PHASE 1 SITE PLAN

MARKETPLACE AT EL PASEO

HERNDON AVENUE AND BRYAN AVENUE
FRESNO, CALIFORNIA

A1.21

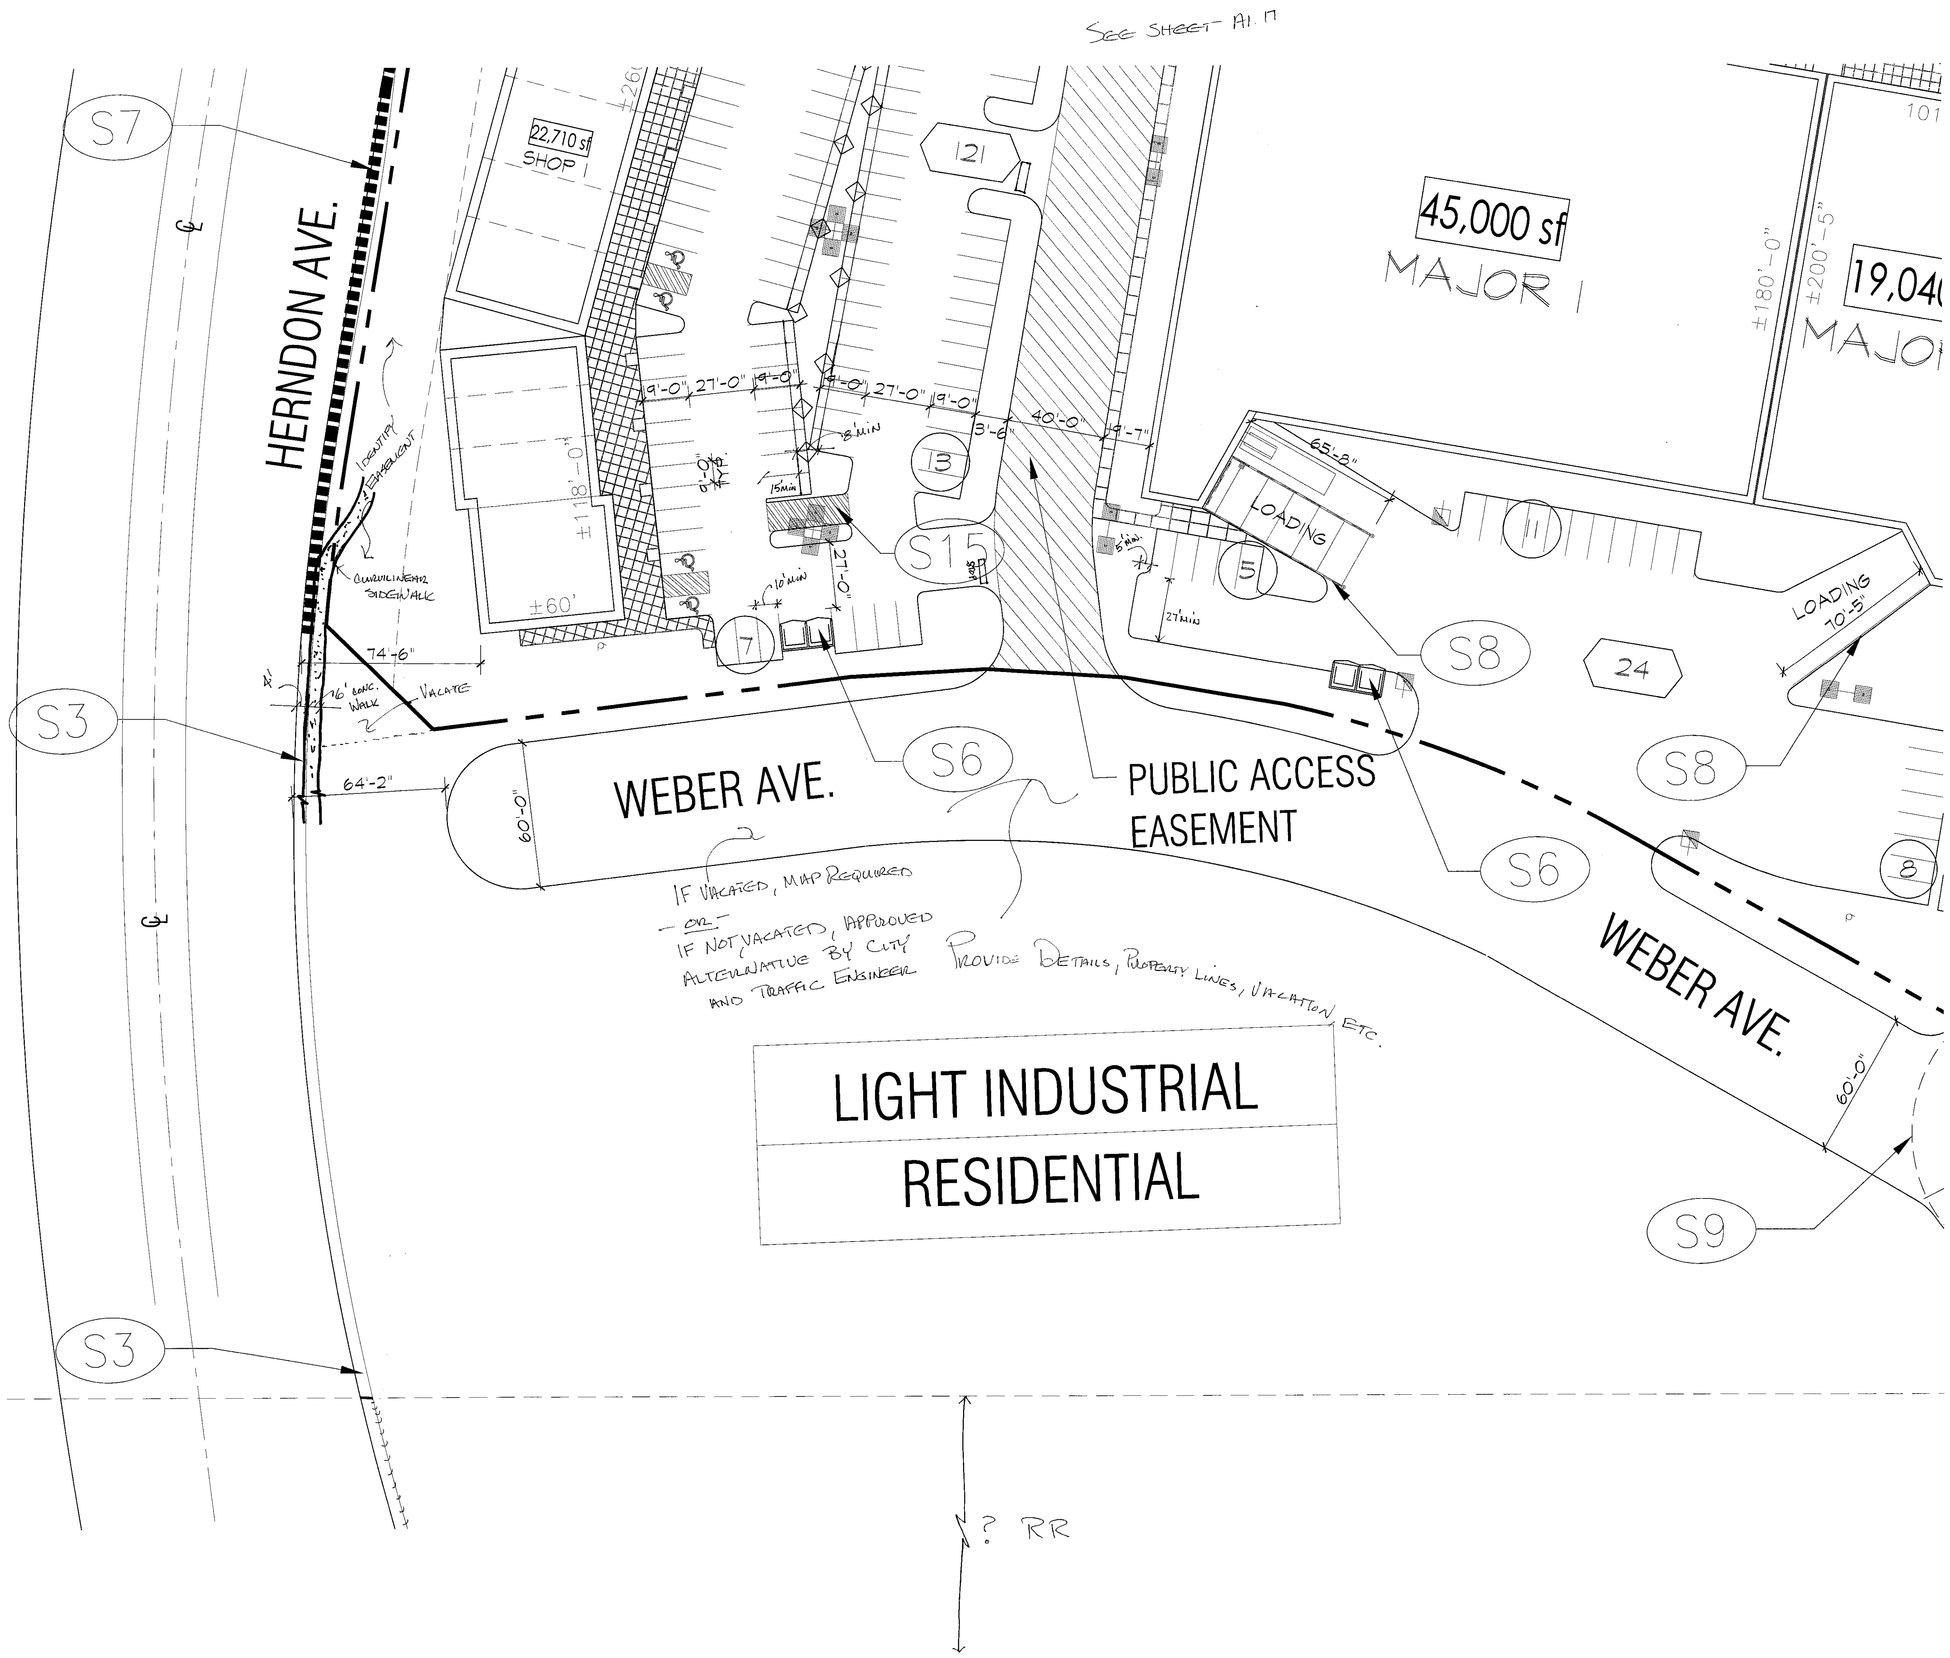
- S1 TRAFFIC SIGNAL
- S2 MONUMENT SIGN, TYPICAL
- S3 SIDEWALK PER STREET SECTION ADJACENT TO HERNDON
- S4 10' MEANDERING SIDEWALK ADJACENT TO BRYAN
- S5 PARK & RIDE
- S6 TYPICAL TRASH ENCLOSURE
- S7 PEDESTRIAN PATH, CONSTRUCT TO RR PROPERTY LINE.
- S8 6' SCREEN WALL, TYP.
- S9 TRUCK TURNING PATH
- S10 ACCENT PAVING
- S11 6' HIGH PIPE FENCE
- S12 20' SEWER EASEMENT
- S13 PG&E EASEMENT
- S14 OUTDOOR PATIO
- S15 LOADING ZONE
- S16 TRANSIT STOP BUS ENCLOSURE 5'x12'
- S17 DRIVE THRU WINDOW
